Title		
<Title>		
Size	Document Number	Rev
A	<Doc>	<RevCode>
Date:	Friday, October 03, 2008	Sheet 8 of 9

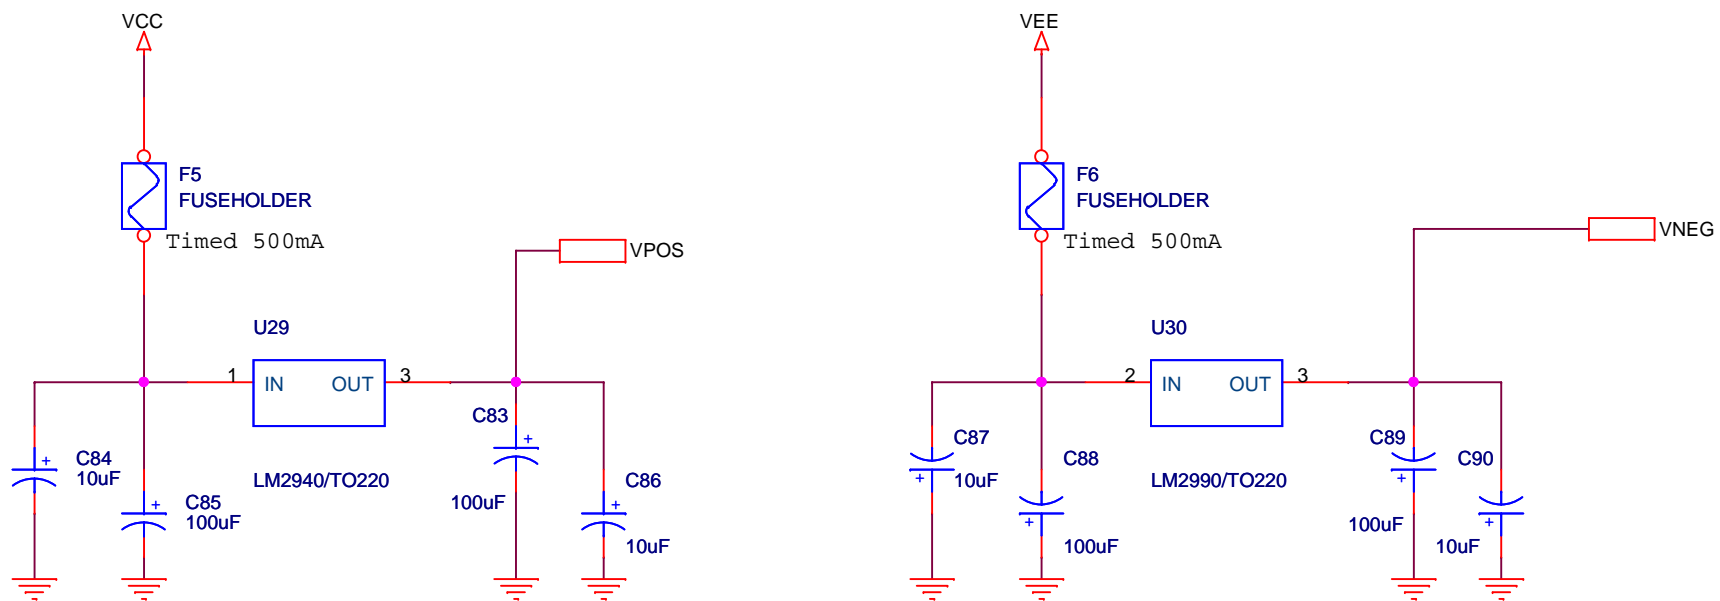
Added a 15V zener between pin 1 (Cathode) & 3 (Anode) of U25 in order to avoid a latch-up problem at startup
 (Use + holes of C68 and C70)

C68, C67, C70, C71, C73, C74 not placed
